## Westmead Catholic Community Section 4.55(1A) Modification Application

This application has been prepared by Ethos Urban on behalf of the Catholic Education Diocese of Parramatta (CEDP) pursuant to section 4.55(1A) of the *Environmental Planning and Assessment Act 1979* (EP&A Act) to modify State Significant Development (SSD) 10383 relating to the redevelopment and upgrades of the existing Westmead Catholic Community (WCC) education campus at 2 Darcy Road, Westmead (the site).

The modification relates to alterations to the approved landscape design to provide more opportunities for active play. The application also seeks to modify various conditions of consent relating to public access over the site, and the preparation of management plans for student and community access to open space.

**Figure 3** Approved and Proposed Level 5 Landscape Design

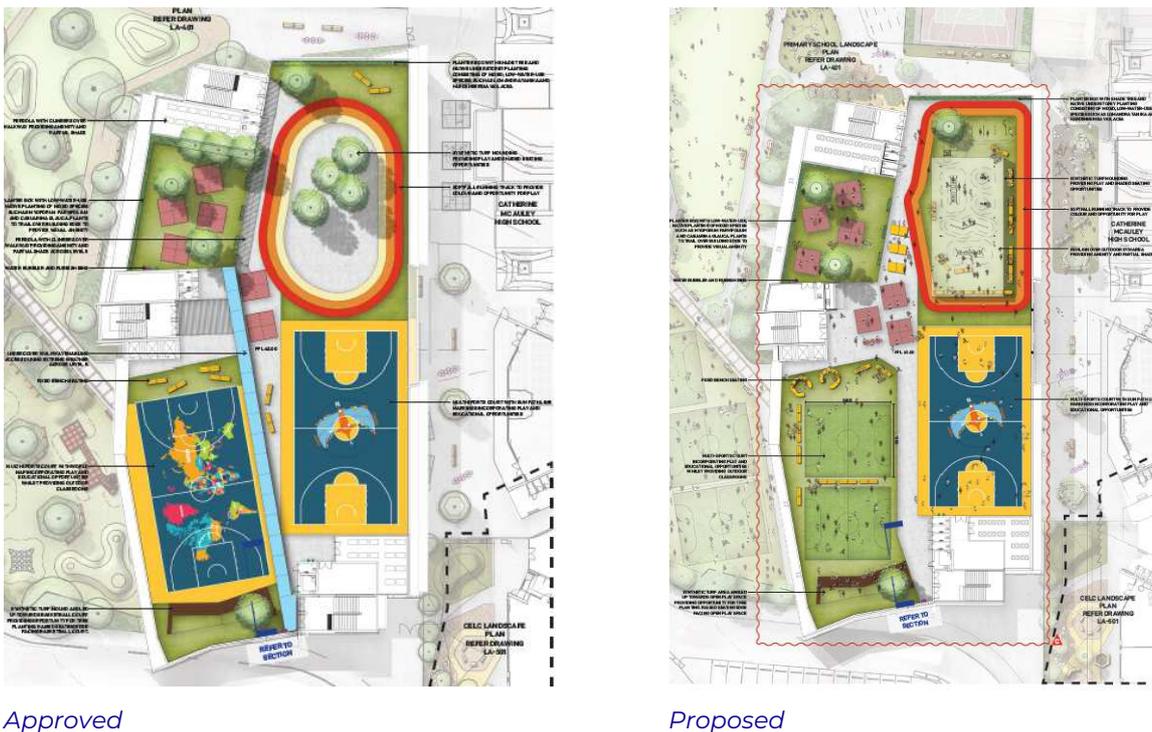
The approved and proposed Level 5 landscape design is shown at **Figure 3** and at **Attachment A**.

Similar to the approach adopted at Ground Level, the design has been amended to provide more opportunities for students to participate in active play and ball sports. One of the lined multi-sports courts has been replaced with two (2) small synthetic soccer pitches. Similarly, some passive play spaces have been removed and replaced with more active play spaces.
